Town of Medway
DESIGN REVIEW COMMITTEE
155 Village Street
Medway MA 02053
508-533-3291
drc@townofmedway.org

RE: DRC Sign Design Review
Rocky's ACE Hardware
98 Main Street
Medway, MA 02053

1) 120 sf centered
 Rocky's 35.5" x 240"
 ACE 30"x 70.375"
 Hardware 25.5"x 159.25"
 Total Boxed SF 120
 Overall 7'6" x 26'5"

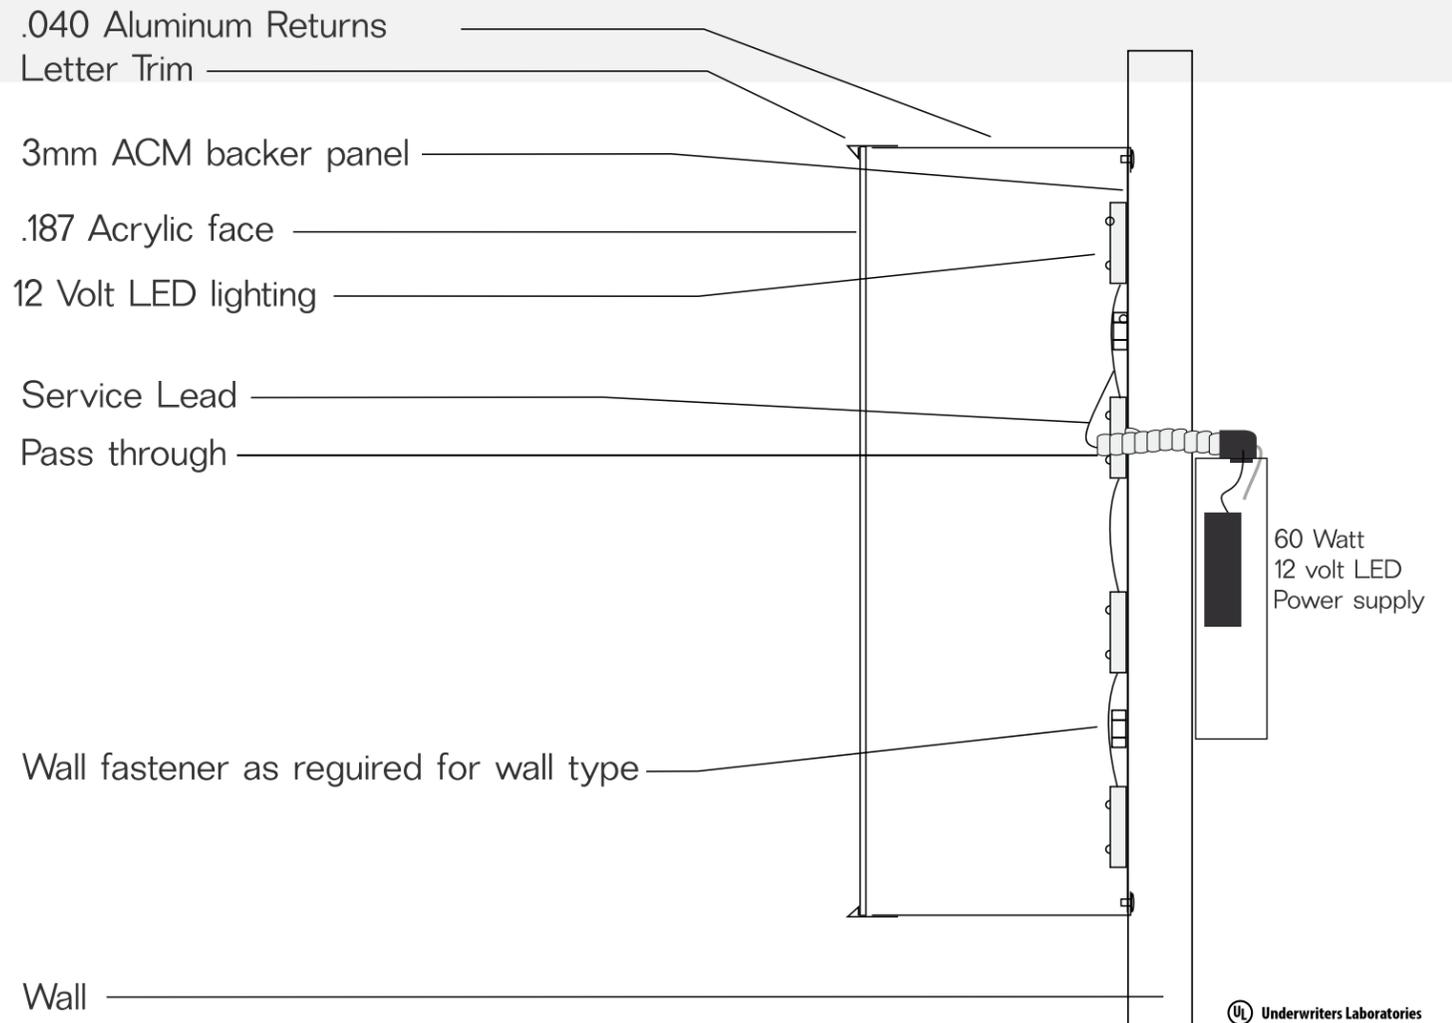
The DRC requested that an updated rendering of the sign be submitted with the sign permit application to the Building Department. This drawing should include a revision date and accurate measurements for the sign as well as a detailed image of the proposed sign instead of the curbside photo of the proposed sign and façade. Based on discussion at the June 7th meeting, we understand the actual sign dimensions are 72" by 240", not the overall 7'6" by 26'5" as indicated on the provided drawing.

- Clean, prepare and paint the existing stucco façade to remove any ghosting and eliminate the many existing holes and imperfections from prior tenant signage, to allow a cleaner appearance to the existing fascia and for the new sign.

- Set lighting of the sign to an appropriate brightness and set to a timer that will shut the sign off after business hours.
- Consider lower color temperatures for the LEDs (below 5000K) to avoid blue appearance to white lettering.
